Model: Martini-C1 Finisher (SR860/SR850)		Date: 13-Nov-02	No.: MB468001
Modified Article: Slide Rail Bracket Screw		Prepared by: M.Tsuyuki	
From: Technical Services sec. Service Planning Dept.			
Reason for Modification:	<input type="checkbox"/> Parts catalog correction	<input type="checkbox"/> Vendor change	<input type="checkbox"/> To meet standards ()
	<input type="checkbox"/> To facilitate assembly	<input checked="" type="checkbox"/> To improve reliability	
	<input type="checkbox"/> Part standardization	<input type="checkbox"/> Other

Model: Martini-C1 Finisher (SR860/850)		Date: 17-Dec-02	No.: MB468002
Modified Article: Tension Spring (B468 Only)		Prepared by: K. Miura	
From: Technical Services sec. Service Planning Dept.			
Reason for Modification:	<input type="checkbox"/> Parts catalog correction	<input type="checkbox"/> Vendor change	<input type="checkbox"/> To meet standards ()
	<input type="checkbox"/> To facilitate assembly	<input checked="" type="checkbox"/> To improve reliability	
	<input type="checkbox"/> Part standardization	<input type="checkbox"/> Other

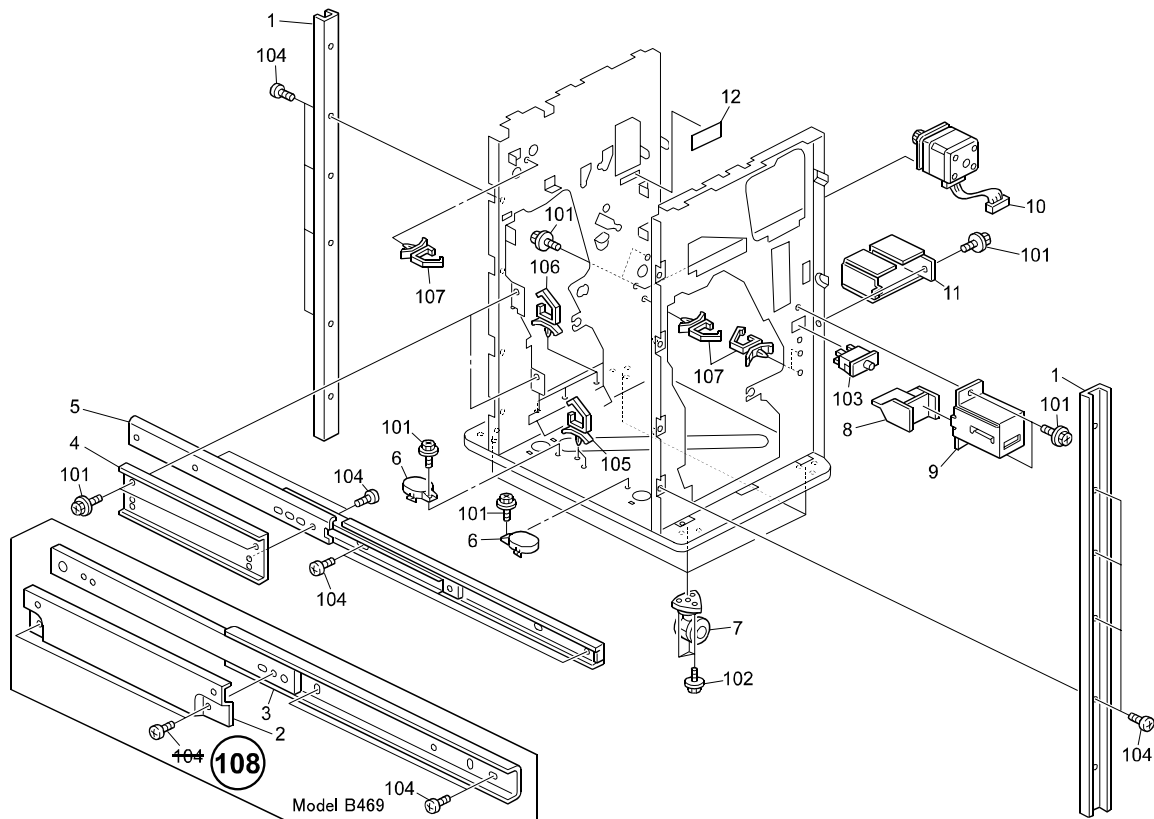
The screws that fixed slide rail bracket may loosen because of vibration during transportation. To prevent this, the following part has been changed:

Old part number	New part number	Description	Q'ty	Int	Page	Index	Note
04533006B		Tapping Screw - M3x6			45	104	
	→09503006B	Sem,s Screw - M3x6		X/O	45	108

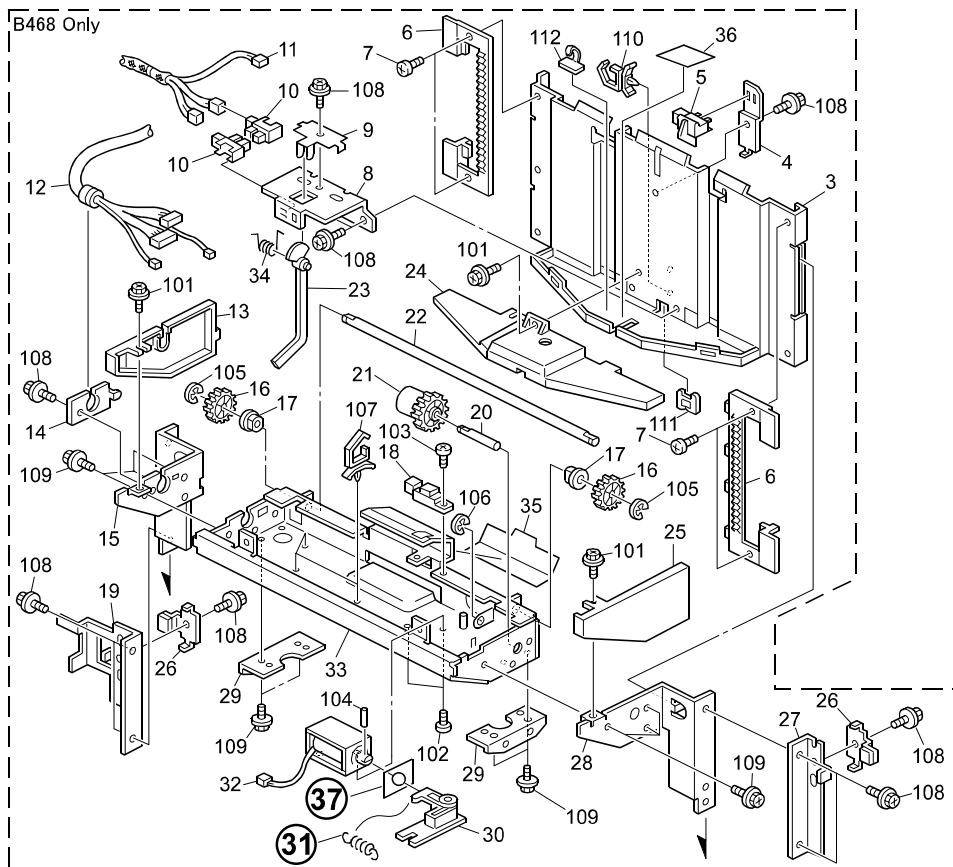
The tension of the spring for the End Fence Spring Clutch has been reduced to ensure the clutch is not damaged when the solenoid turns off. In addition, a cushion has been added to ensure noise does not occur between the solenoid and release lever from the reduced spring tension.

Old part number	New part number	Description	Q'ty	Int	Page	Index	Note
B4683146	B4683145	Tension Spring	1	X/O	33	31	
	B4683143	Cushion - Solenoid Spring Clutch	1		33	37

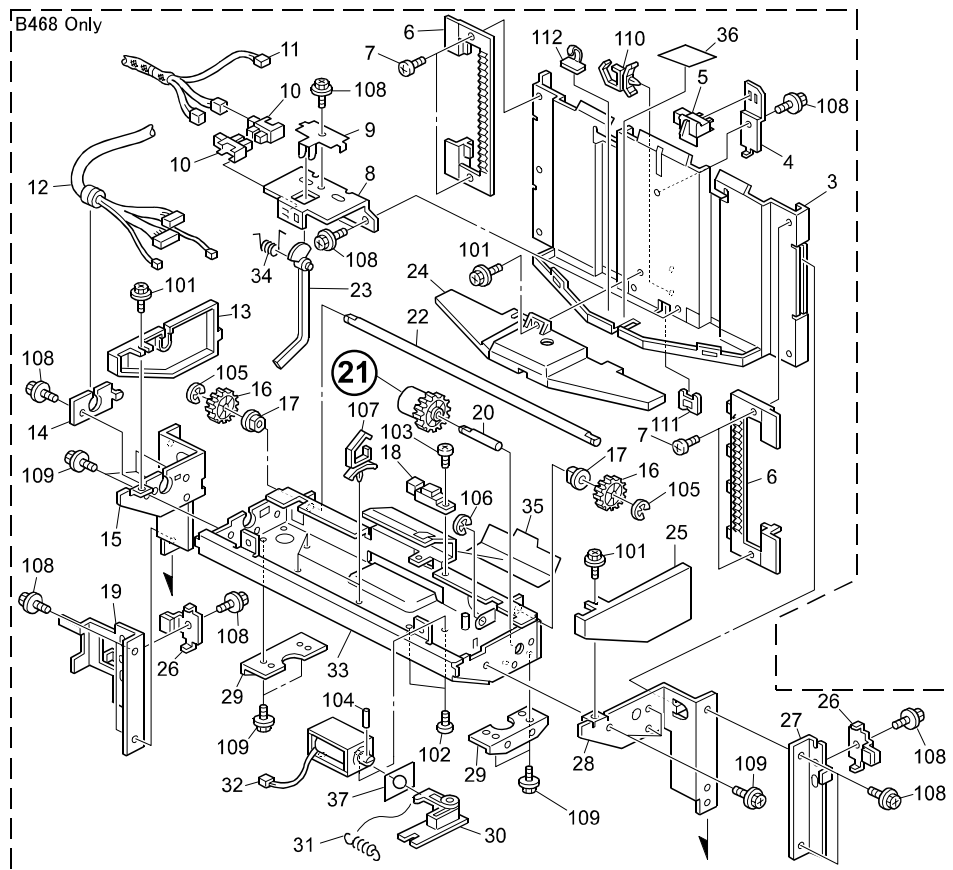
The material of the spring in the Spring Clutch has been changed to metal to increase clutch durability.

Old part number	New part number	Description	Q'ty	Int	Page	Index	Note
B4683149	B4683196	Spring Clutch - End Fence	1	X/O	33	21

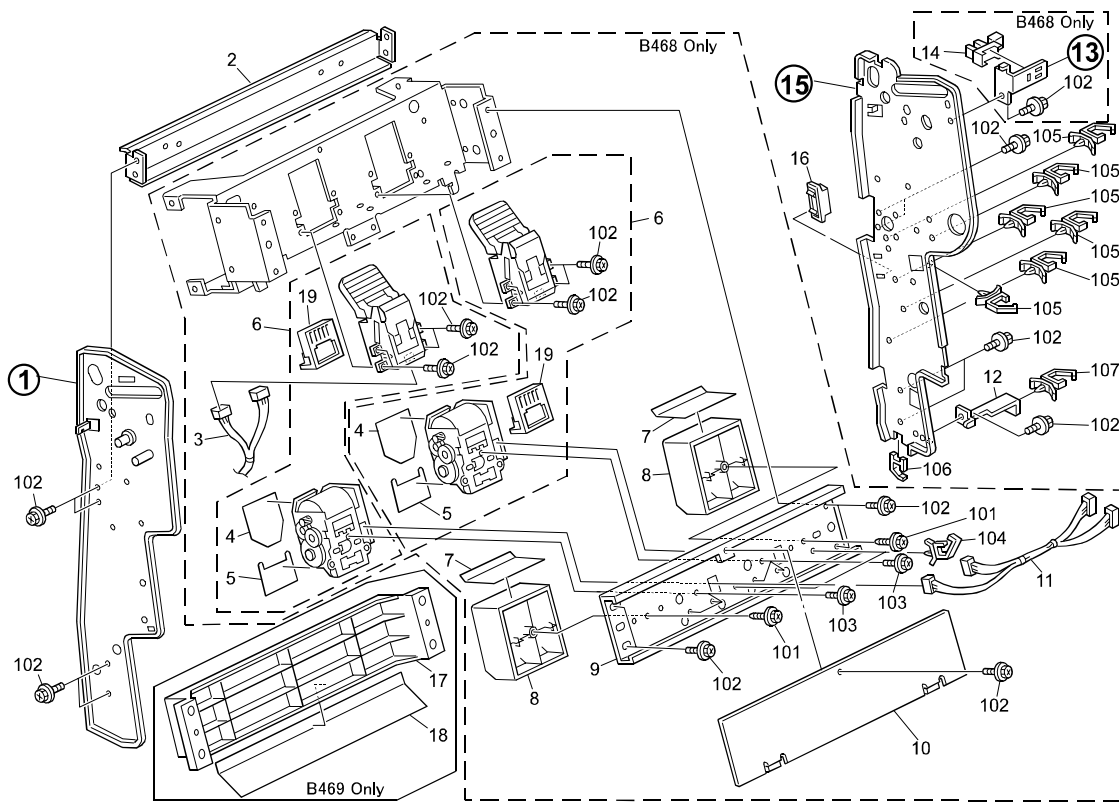
The following have been changed to ensure that when selecting two-position stapling, the staple stay is not deformed by the weight of the staple unit, which can cause the rear staple to shift to the left.

Old part number	New part number	Description	Q'ty	Int	Page	Index	Note
B4684211	B4684215	Front Side Plate (B468)	1	X/X	25	1	A
B4684212	B4684216	Front Side Plate (B469)	1	X/X	25	1	B
B4684221	B4684225	Rear Side Plate (B468)	1	X/X	25	15	A
B4684222	B4684226	Rear Side Plate (B469)	1	X/X	25	15	B
B4684555	B4684556	Stapler Guide Rod	1	X/X	27	13	A, B

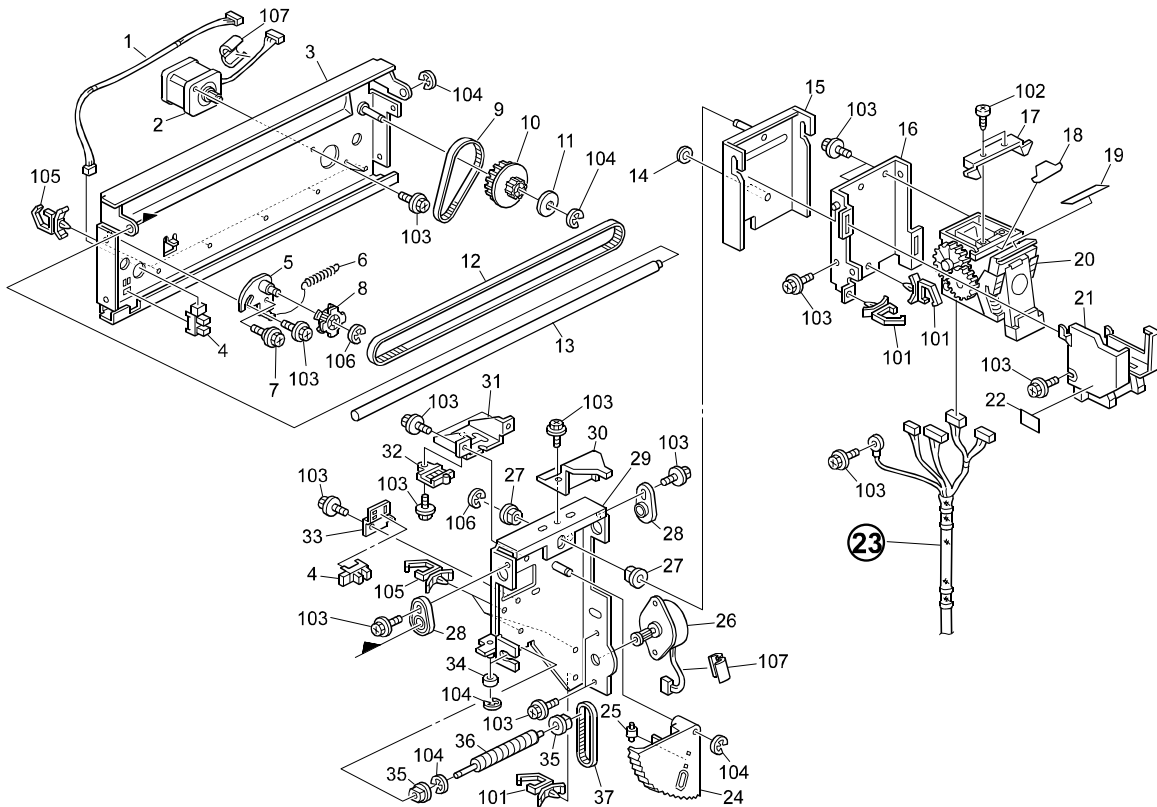
To facilitate assembly, the following part has been changed:

Old part number	New part number	Description	Q'ty	Int	Page	Index	Note
B4685450	B4685455	Stapler Harness	1	O/O	27	23

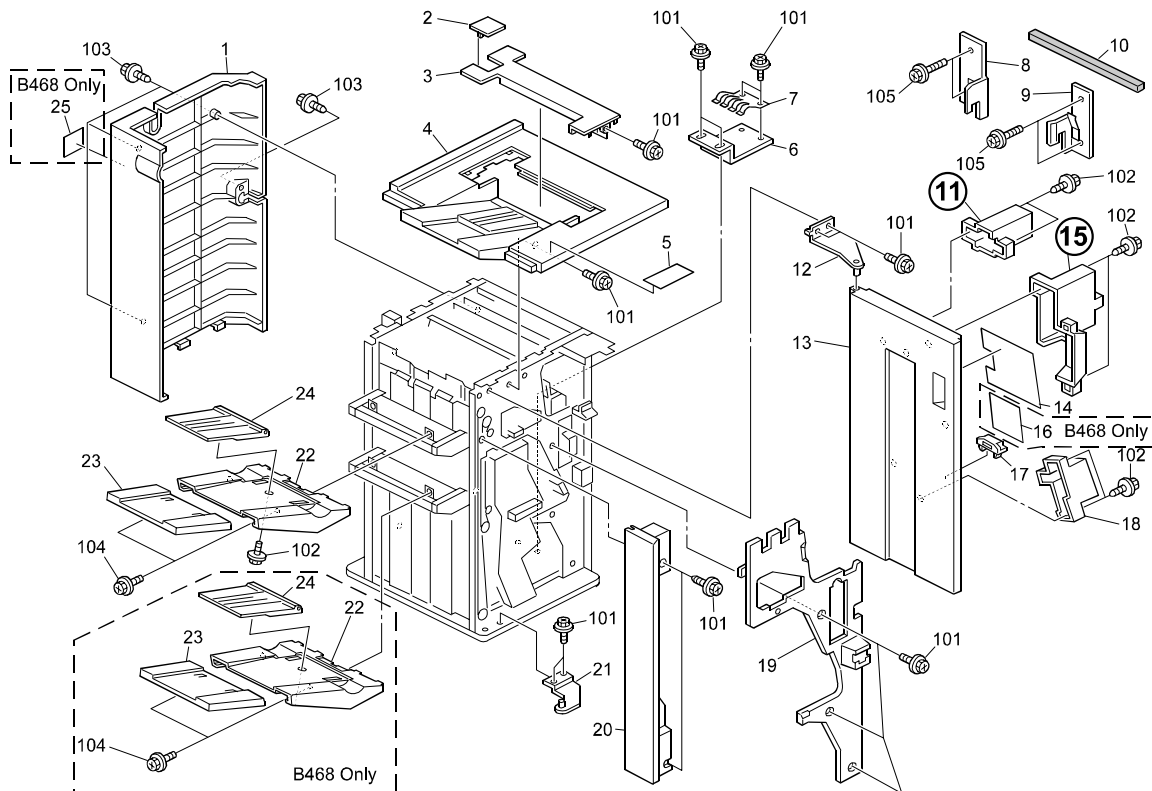
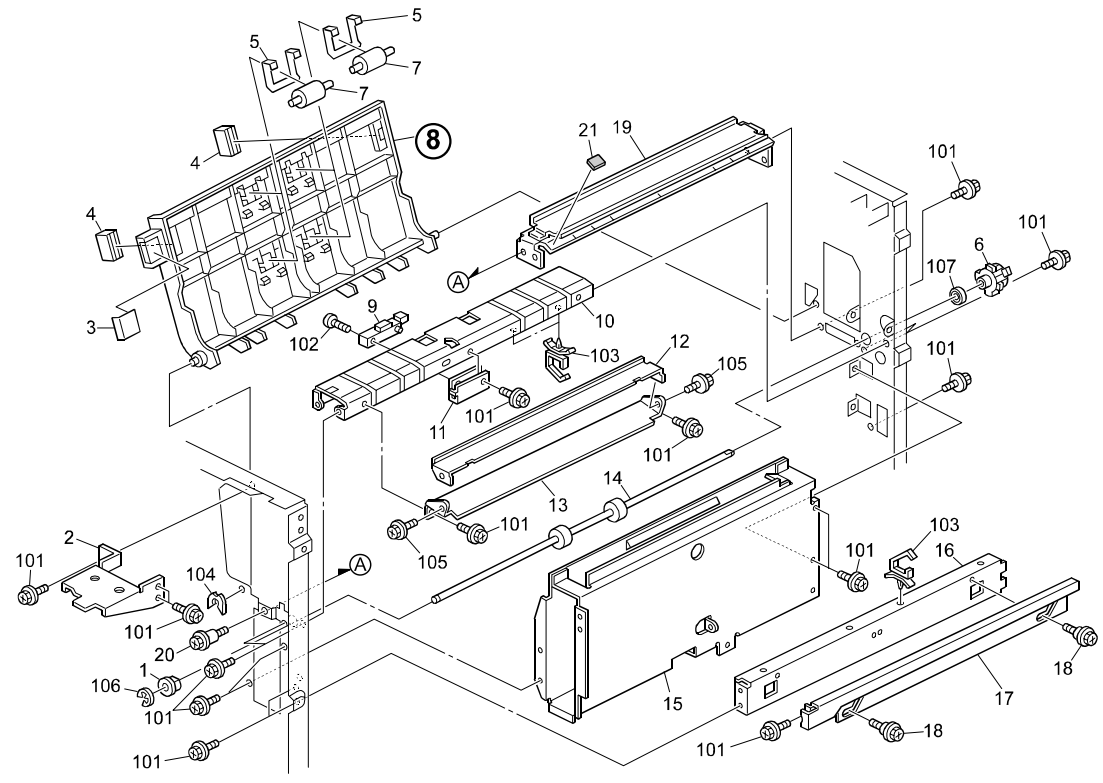
When closing the front door without repositioning the R2 or R3 lever, the shaft of the lever may be damaged. To prevent this, the following parts have been changed:

Old part number	New part number	Description	Q'ty	Int	Page	Index	Note
B4681622	B4681627	Front Grip	1	X/X	7	15	
B4681623	B4681628	Upper Stopper	1	X/X	7	11	
B4682152	B4682153	Upper Guide Plate	1	X/X	9	8

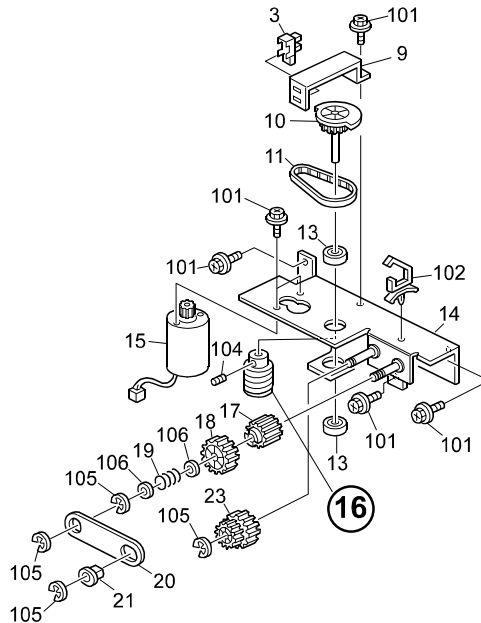
To prevent abrasion, the following parts have been changed:

Old part number	New part number	Description	Q'ty	Int	Page	Index	Note
AB013709	A3002736	Worm Gear	1	X/O	39	16

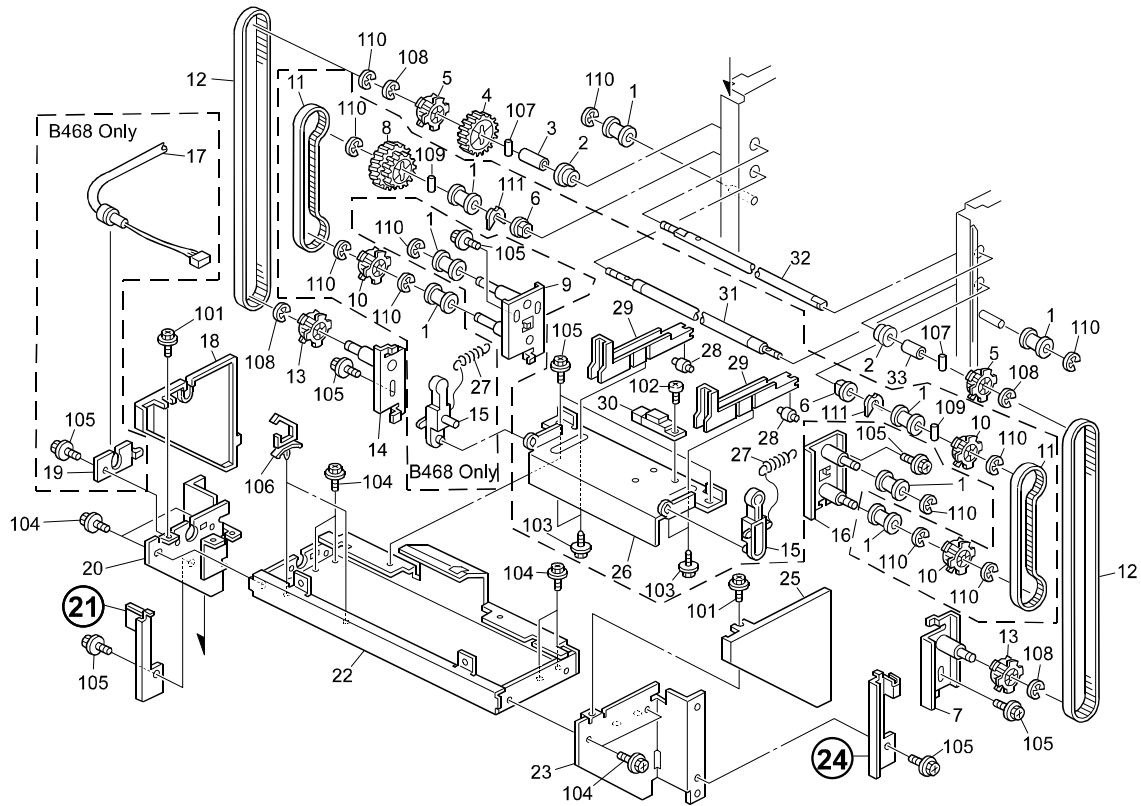
To prevent damage to the timing belt, the following parts have been changed:

Old part number	New part number	Description	Q'ty	Int	Page	Index	Note
B4683231	B4683233	Front Stopper	1	X/O	35	21	
B4683232	B4683234	Rear Stopper	1	X/O	35	24

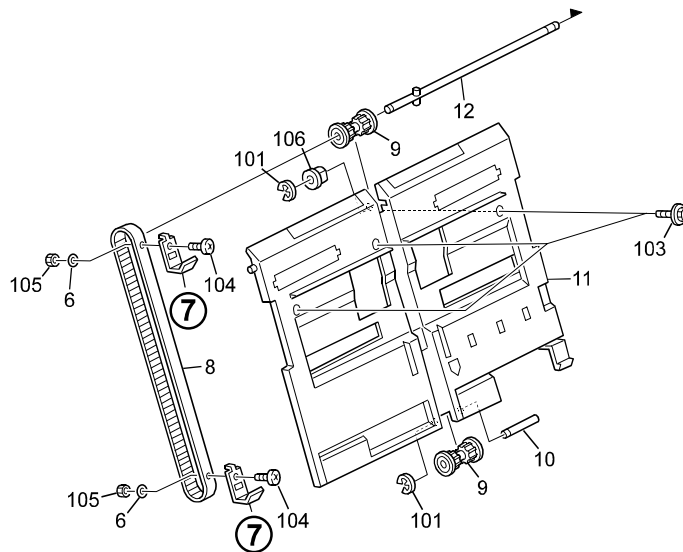
To prevent the deformation of the exit belt pawl, the following part has been changed:

Old part number	New part number	Description	Q'ty	Int	Page	Index	Note
B4684144	B4684147	Exit Belt Pawl	2	X/O	23	7

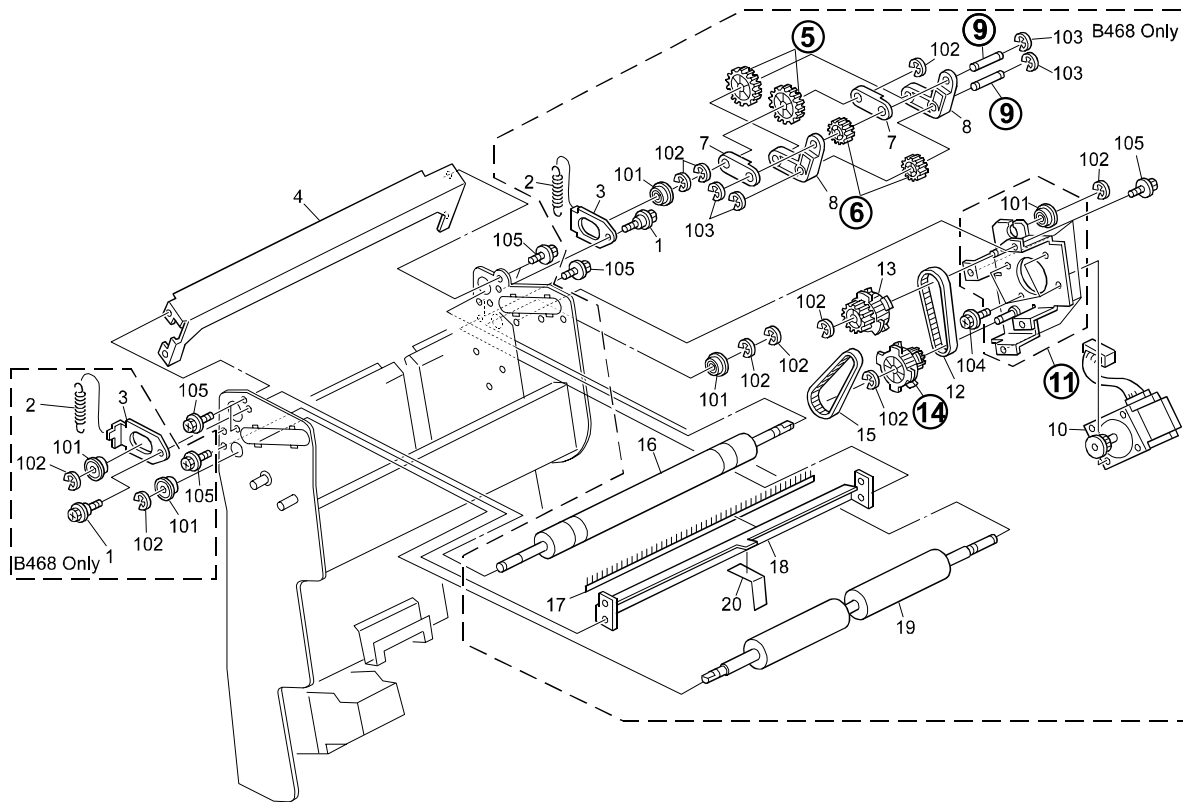
To increase durability, the materials of the following parts have been changed:

Old part number	New part number	Description	Q'ty	Int	Page	Index	Note
B4684651	B4684628	Drive Gear	2	X/O	31	5	
B4684624	B4684627	Gear - 18Z	2	X/O	31	6	
B4684623	B4684629	Roller Shaft	2	X/O	31	9	
B4684635	B4684634	Bracket	1	X/O	31	11	
<i>B4684652</i>		<i>Idler Pulley - T20P5MZ20</i>	1	X/O	31	13	
	B4684649	Idler Pulley - T20P5M	1	X/O	31	13

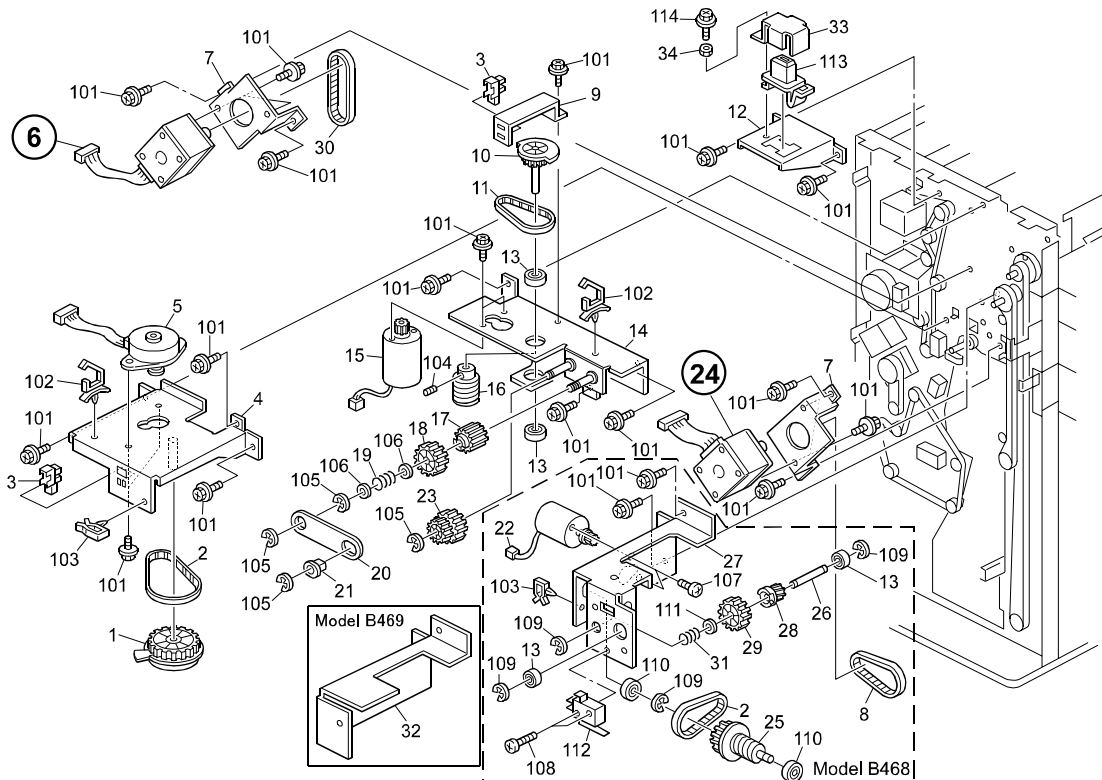
Please correct your Parts Catalog as follows:

Old part number	New part number	Description	Q'ty	Int	Page	Index	Note
B4685755	B4685750	Stepper Motor	1	-	39	6	
B4685750	B4685755	Stepper Motor	1	-	39	24

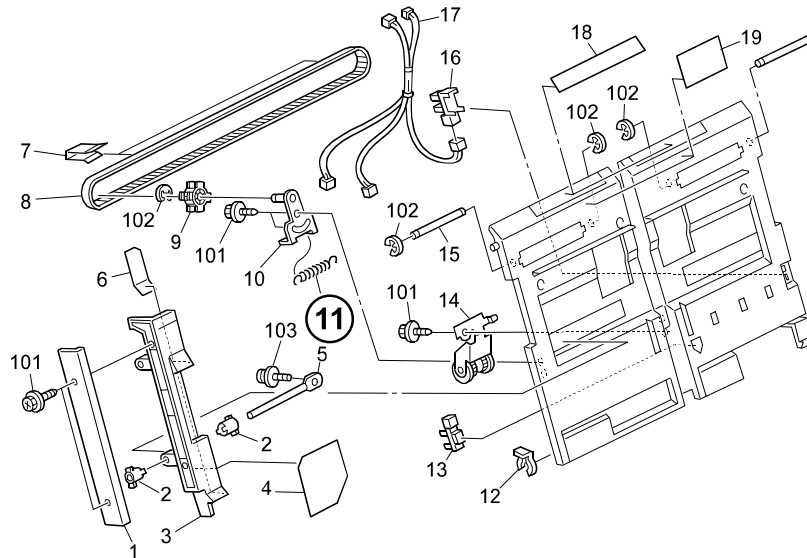
The following has been changed to ensure that proper tension is maintained in the jogger drive belt under low temperature conditions.

Old part number	New part number	Description	Q'ty	Int	Page	Index	Note
A6971518		Spring - Oil Blade	1		21	11	
	B4684333	Tension Spring - 10.6N	1	X/O	21	11
